Subject: **COLUMBIA GENERATING STATION, DOCKET NO. 50-397
ENERGY NORTHWEST'S FIRST SIX-MONTH STATUS UPDATE
REPORT FOR THE IMPLEMENTATION OF NRC ORDER EA-13-109 –
OVERALL INTEGRATED PLAN FOR RELIABLE HARDENED
CONTAINMENT VENTS UNDER SEVERE ACCIDENT CONDITIONS**

**FIRST SIX-MONTH STATUS UPDATE REPORT FOR THE IMPLEMENTATION OF
NRC ORDER EA-13-109**

4.0 Changes to Compliance Method

New Sketch 3 – Flow Diagram

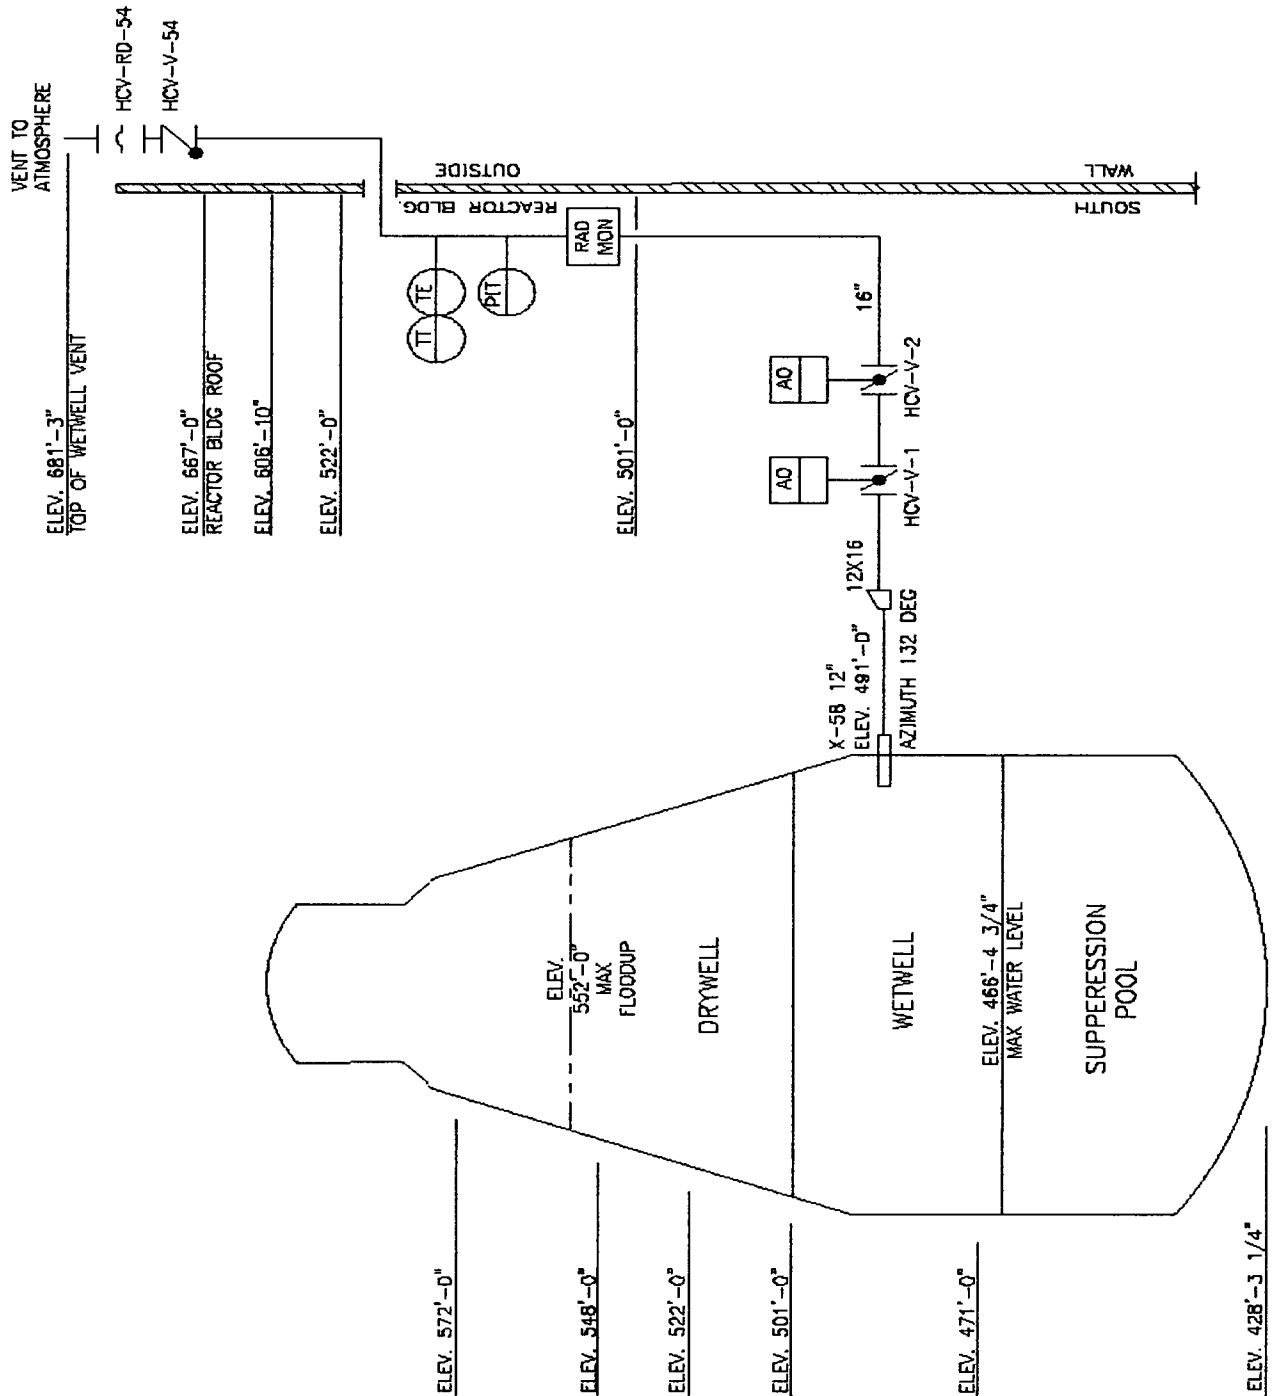
PLT-5 Identified three valves, HCV-1, 2, and 7. HCV-V-7 has been replaced by a rupture disc. Energy Northwest is eliminating valve HCV-V-7 and adding a rupture disk HCV-RD-54 to prevent secondary containment bypass leakage. As a result a separate nitrogen supply will be added for use in rupturing the disk if anticipatory venting is to be performed. This will be a manual action in the area of the remote operating station. To prevent inadvertent operation of the WW HCV, instead of the solenoid pilot valves being located in a locked cabinet, the remote operating station will have lockable pneumatic supply valves. A new Sketch 3 is attached.
